FIGG Structural Analysis Presentation
University City Prosperity Project (BT-904)
Pedestrian Bridge over Tamiami Trail US 41
Contract No.: ARI73 FM No.: 434688-1

Date: 03/15/18 Time: 9:00 AM Location: MCM Field Office

The shims placed during the span move were:

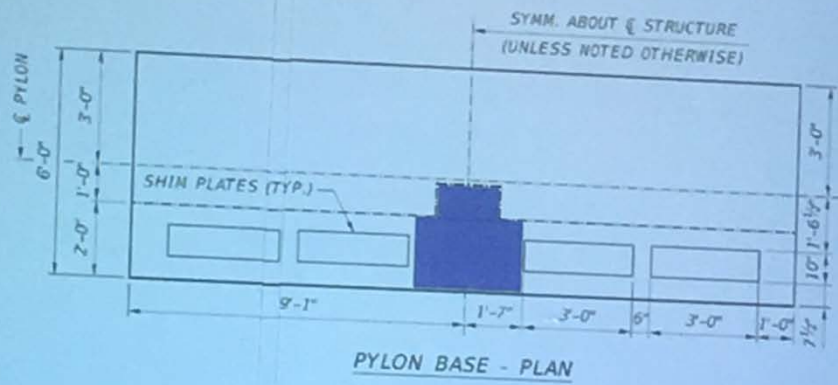
- Tuesday morning, upon seeing MCM's information, FIGG requested that, as a prudent action, MCM immediately install temporary shims directly below the nodal area of members 11/12 and the top of the Pylon/Pier, while further evaluations were on-going by FIGG.

The recommended temporary shimming region is shown below, in blue:

Design re-checks: Flexure stresses on the bottom of the transverse diaphragm beam

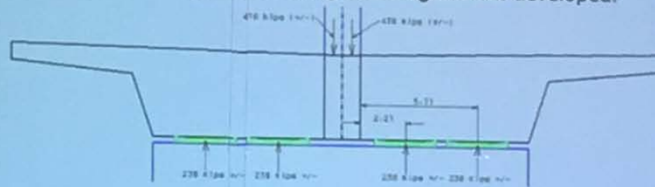
- The field operations were conducted with the intent of achieving reasonably equal loads at the 4 shim locations.
- Assuming that that was achieved, and that the span weighs 950 tons (Barnhart told us that it was somewhat less; we are trying to get the as-weighted value), the following load diagram was developed:

- Bending Moment (M) = $238 \times (2.12 + 5.71) = 1865$ kip-ft +/-
- Beam cross section (4' tall) by (2' wide)
- Bending section modulus (S) = $(W \times (H^2)/6) = 5.33$ ft³
- Bending Stress (M/S) = $1865/5.33 = 350$ ksf
- This value is above the concrete (f_r) strength, so cracking of the reinforced concrete element would be expected, as allowed by normal reinforced concrete design methods.

Strut and Tie Design Strength Check

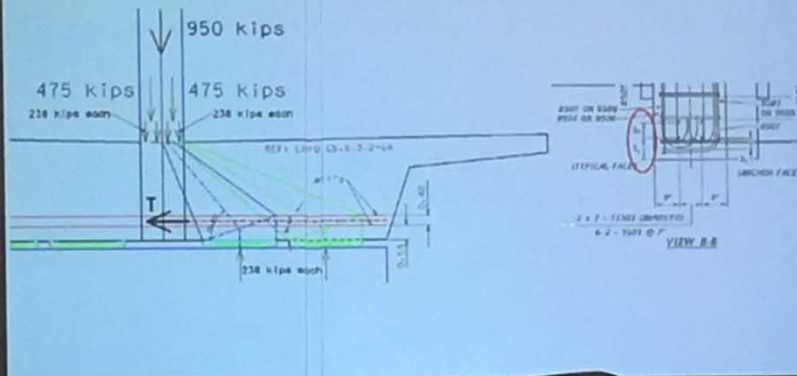
- Given the dimension of this region, the most appropriate design approach is the strut and tie method of LRFD 5.6.3

- $T_1 = 238 \text{ kips} / \tan(50.87 \text{ deg}) = 194 \text{ kips}$
- $T_2 = 238 \text{ kips} / \tan(30.84 \text{ deg}) = 399 \text{ kips}$
- Total Tension (T) = 593 kips (un-factored)

Stress change from placing onto shims

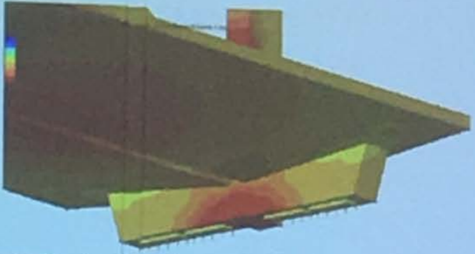
- When the span was placed onto the shims, are the stresses on the diaphragm essentially equal on the North and South Faces, or is one face more highly stressed?

- The results indicate that the stress change on the North and South faces is relatively uniform when the load is transferred to the shims.

Diagonal Crack Pattern

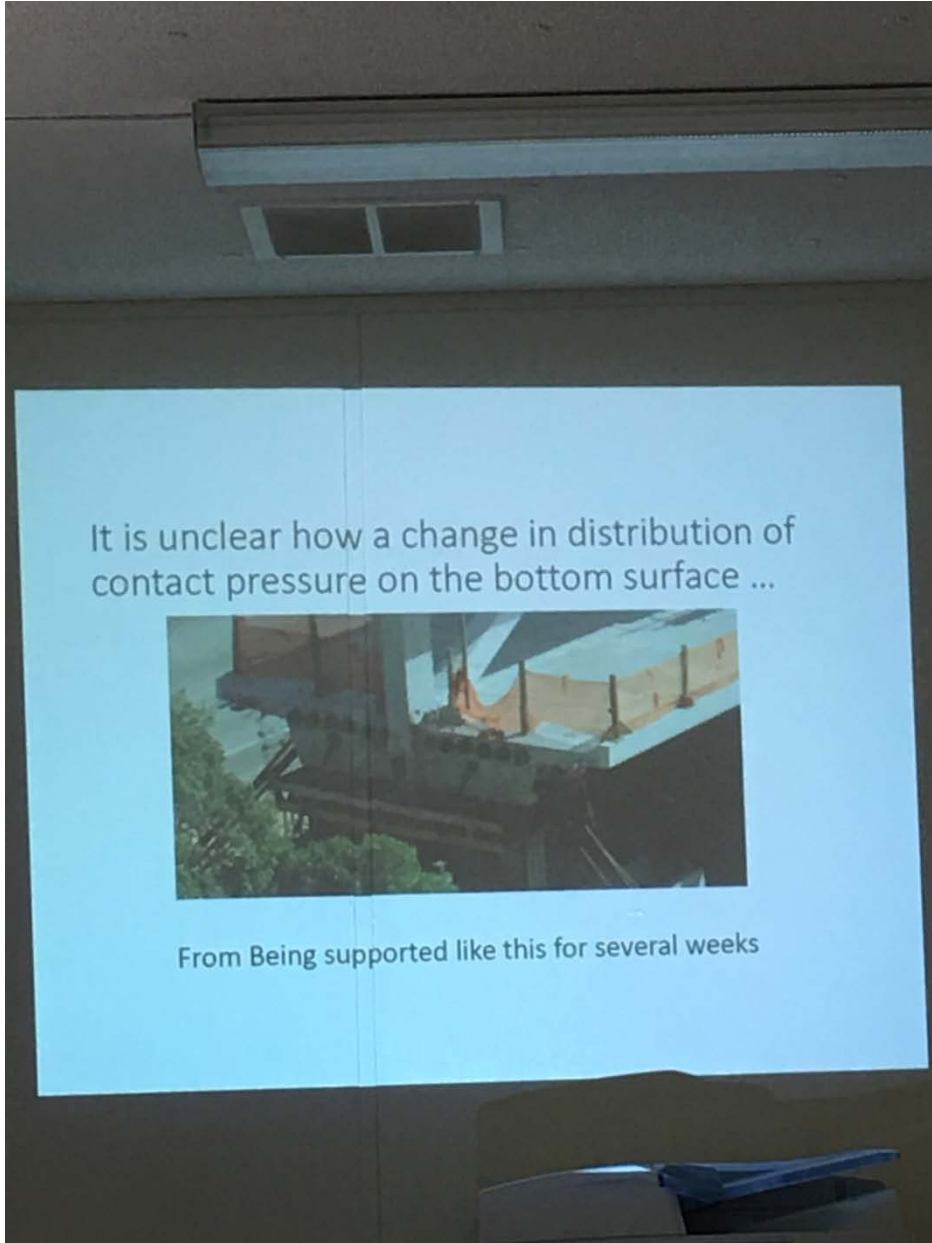
- Both the hand calculations and the 3D volume element analysis concur that some cracks of the nature photographed are possible
- Why the cracks did not develop in the casting area, is likely related to having a substantial portion of the load carried in the central area
- Having the smaller crack width on the permanently exposed face is preferable, when compared to the other (to be embedded) diaphragm face.

- The diagonal type cracks, in excess of FDOT criteria, should be sealed with approved methods and materials (Epoxy injection, etc.)
- The spalled areas have not been replicated by the engineering analyses. However ...
- The spalled areas are minor and it is recommended that they be prepared using normal procedures and poured back along with the up coming "pylon diaphragm" pour (different from and prior to the back span on falsework pours)

The change (principle stresses) solely from
destressing the PT bars in Member 11 are

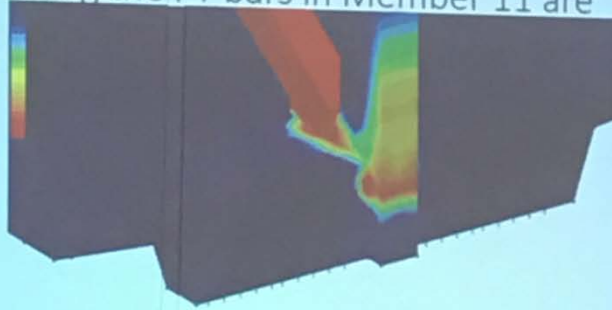
- The analyses (neither total stresses, nor PT bar only stresses) shows any spike in tensile stresses at the corner of the deck/diaphragm/member 12.
